2.3 LANDSCAPE PROPOSALS - STREET FURNITURE

RAILING DESIGN DEVELOPMENT

3D VIEWS OF REVISED RAILING DESIGN

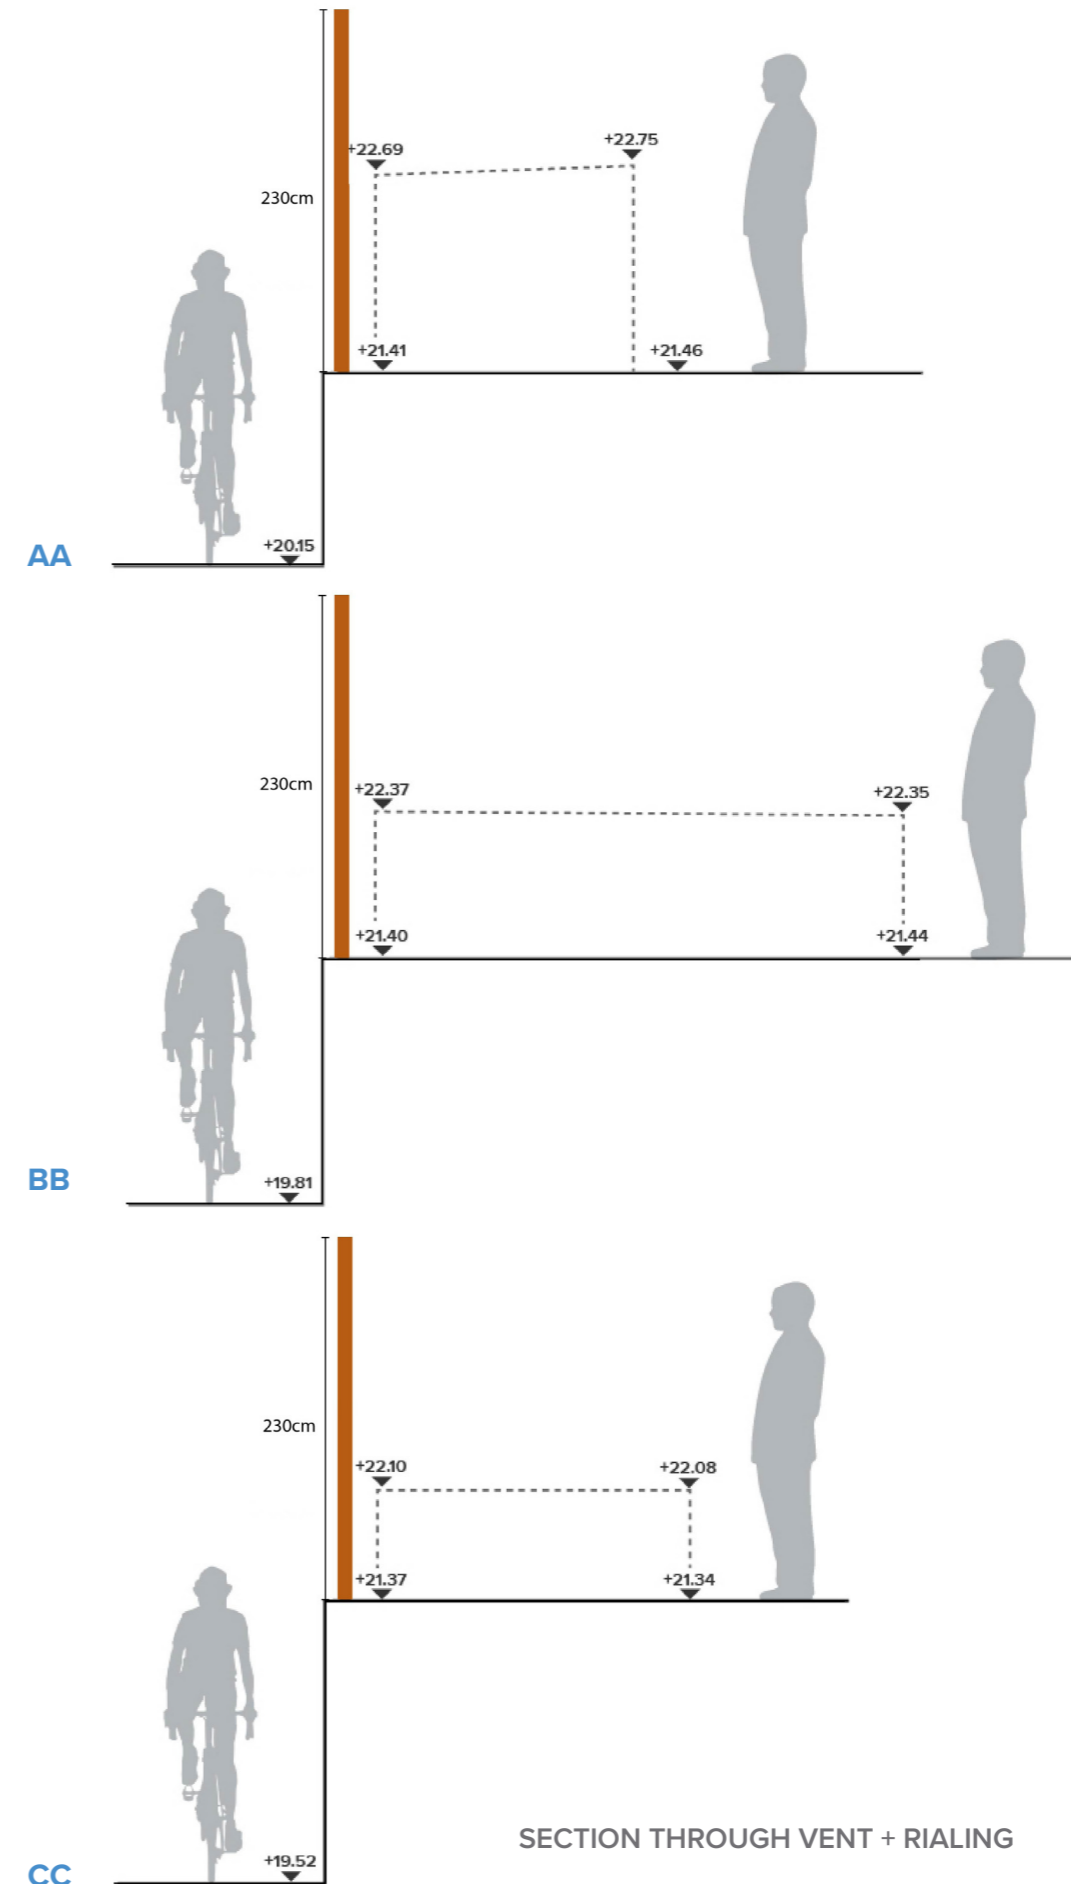
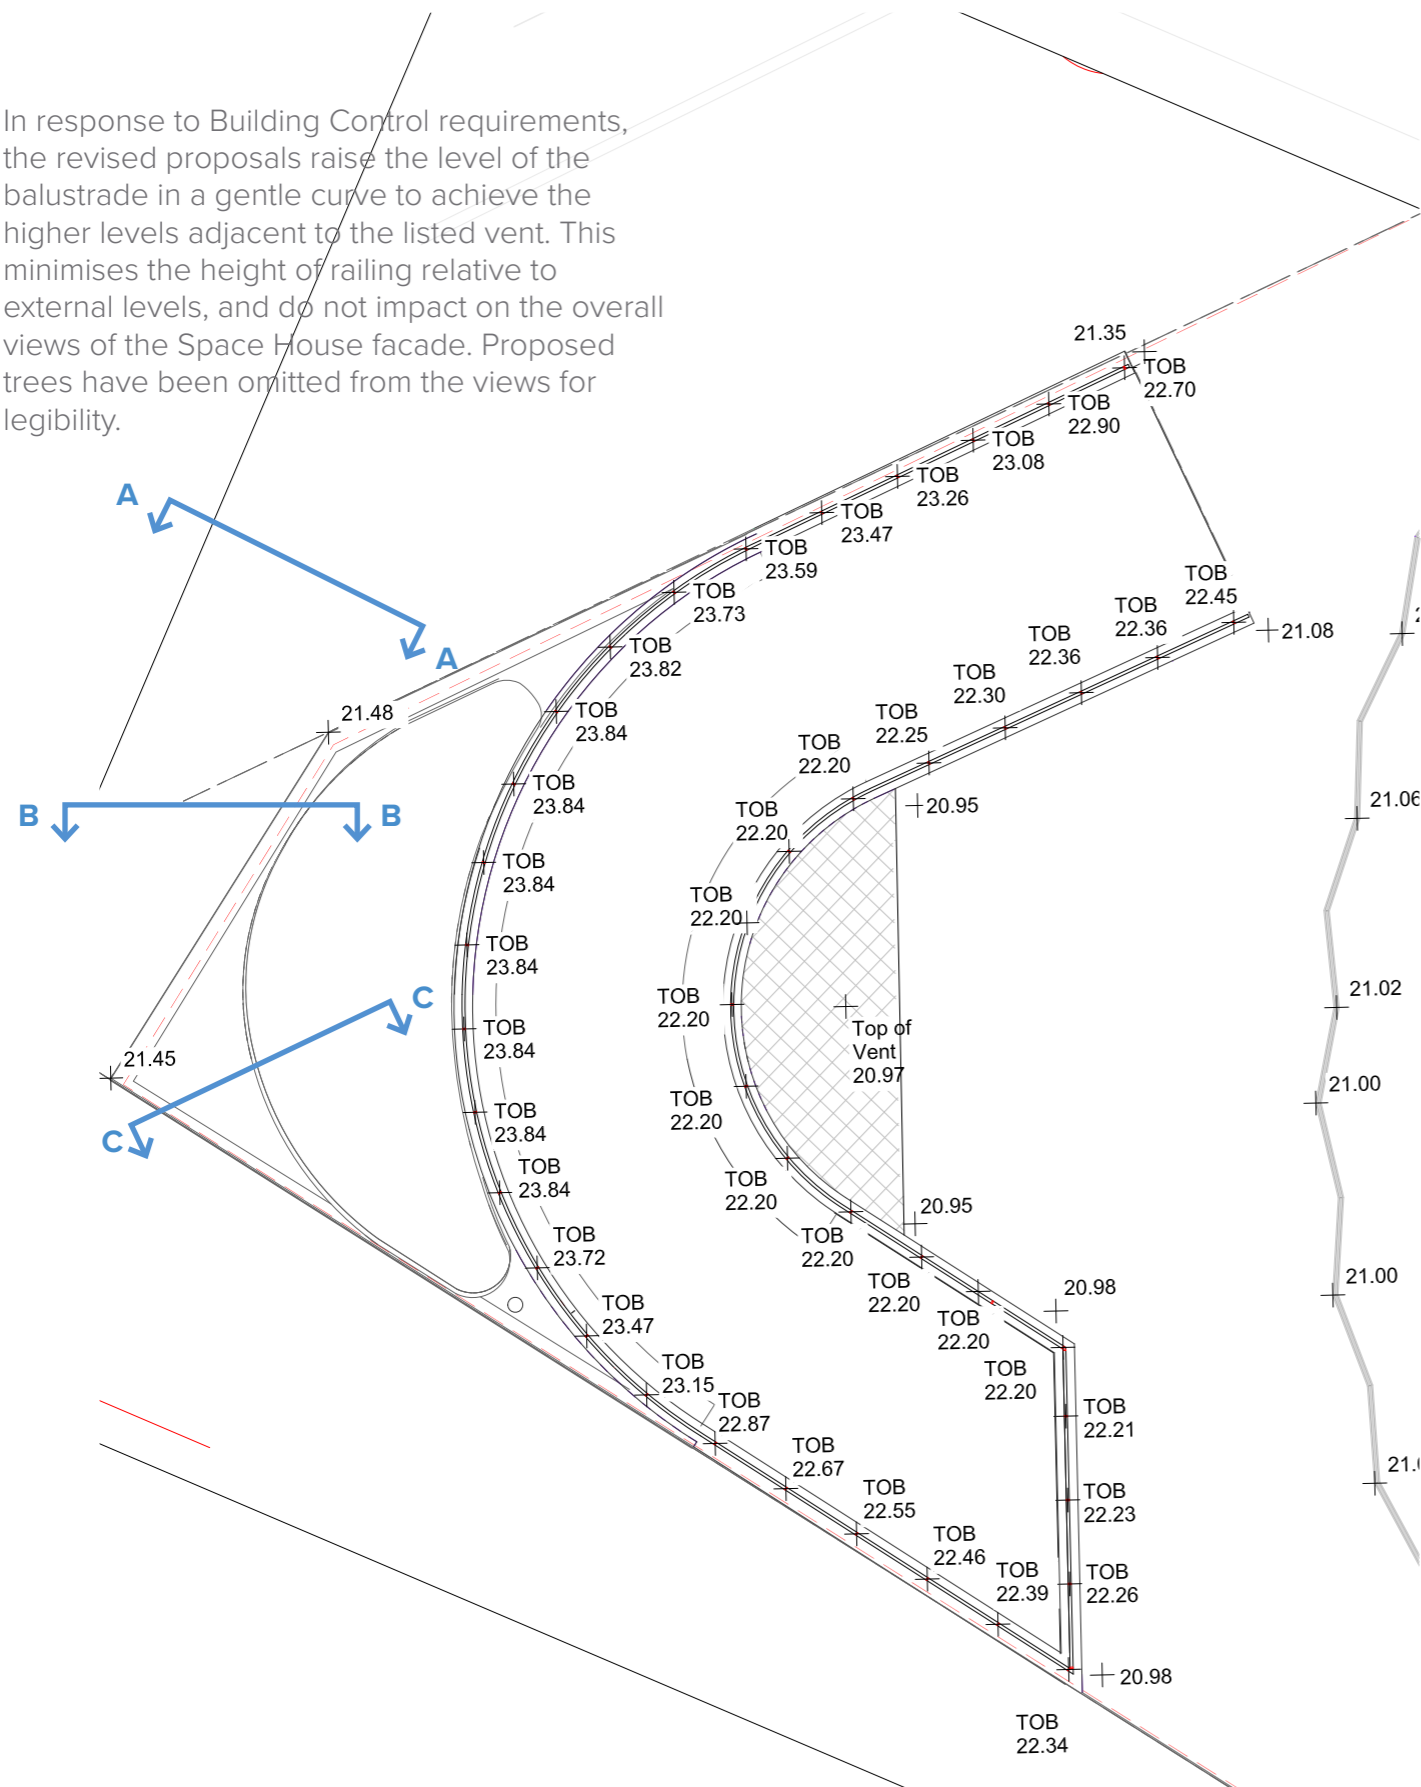
In response to Building Control requirements, the revised proposals raise the level of the balustrade in a gentle curve to achieve the higher levels adjacent to the listed vent. This minimises the height of railing relative to external levels, and do not impact on the overall views of the Space House facade. Proposed trees have been omitted from the views for legibility.

- Raise the railing 110 cm above the vent structure.
- Both sides of the railing extend following the ramps equally and consistently adhere to the vent slope until they reach a height of 120 cm minimum above FFL.
- Proposed Trees omitted from planter for legibility
